**ERRATA SHEET**

**WRIR 86-4358 PLATE 1**

HYDROGEOLOGY OF STRATIFIED-DRIFT AQUIFERS AND WATER QUALITY IN THE NASHUA REGIONAL PLANNING COMMISSION AREA
SOUTH-CENTRAL NEW HAMPSHIRE

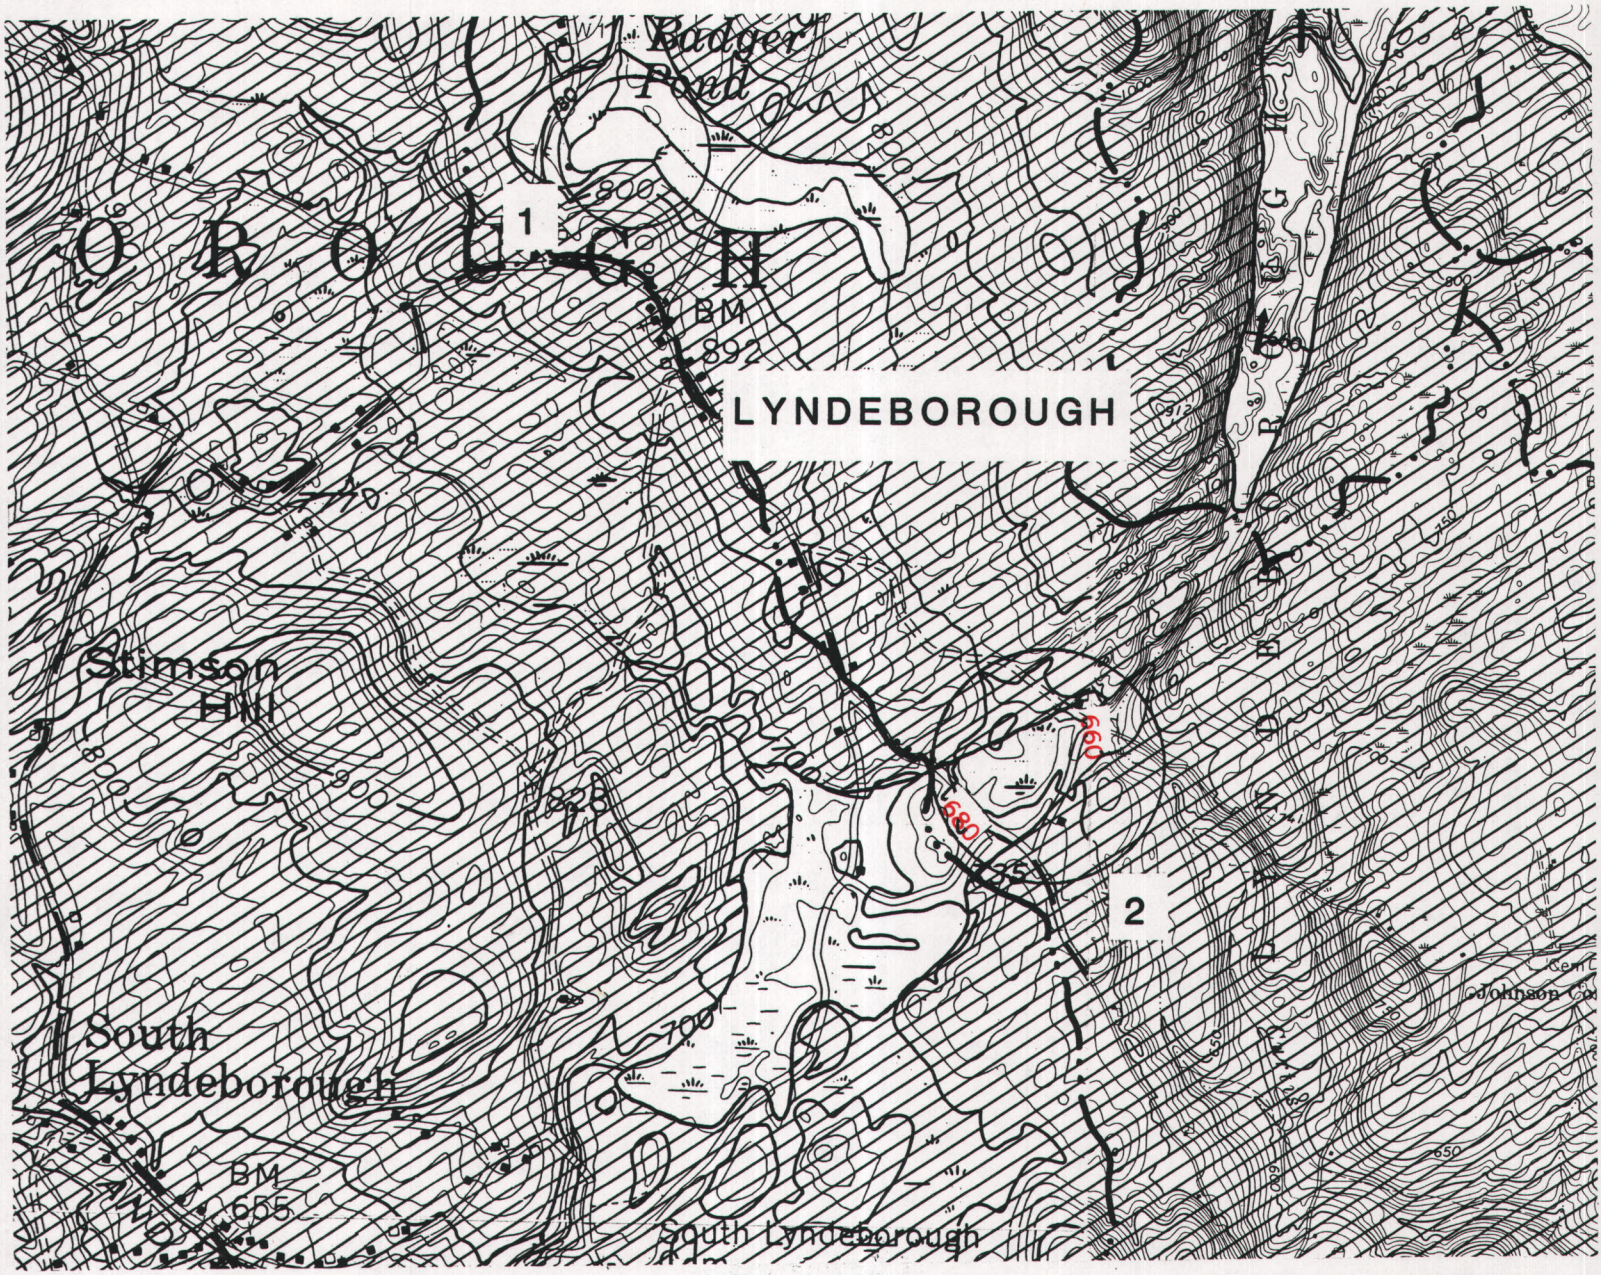
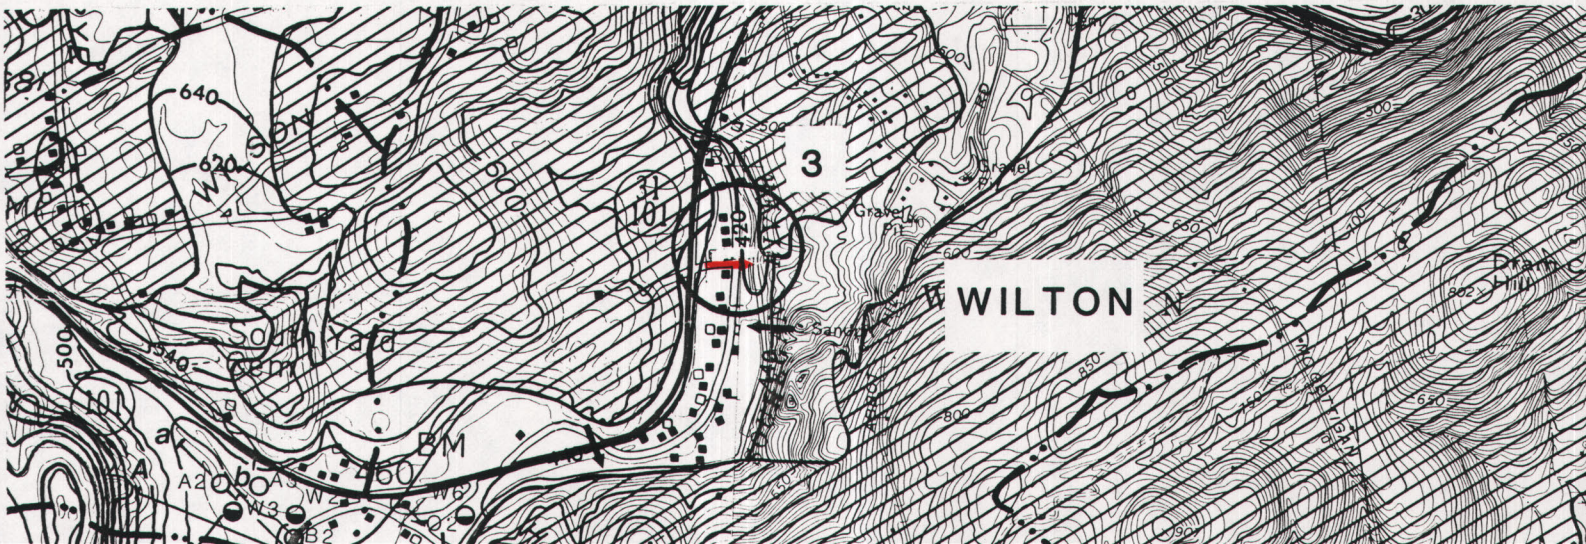
| ERROR | TOWN | NEAREST LANDMARK | CORRECTION |
|---|---|---|---|
| 1 | Lyndeborough | Badger Pond | No till/bedrock pattern over Badger Pond |
| 2 | Lyndeborough | South Lyndeborough Cemetary | Water-table contours 760,780, should be 660, 680, respectively |
| 3 | Wilton | State Route 31/101 crossing Souhegan River | Flow arrows on water-table contour 420, opposite direction |
